# FlexLogix Controller Revision 12 Release Notes

Catalog Numbers 1794-L33, 1794-L34

These release notes should be used with FlexLogix controller firmware **major revision 12, minor revision 28**. Use this firmware with:

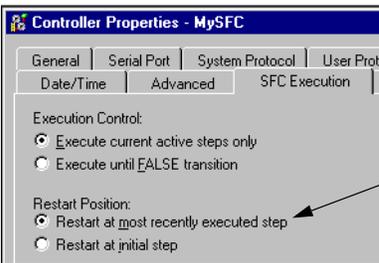
| Change: | Description: |
|---|---|
| Improvements in How an SFC Restarts After Its Execution is Aborted | This revision provides better handling of situations where the execution of a sequential function chart (SFC) was aborted due to:<br><br>• loss of power<br>• controller entered the faulted mode (flashing red OK LED)<br><br>The changes include the following: |

Regardless of this setting, the SFC always restarts at the initial step after a change from faulted mode (flashing red OK LED) to run/remote run mode.
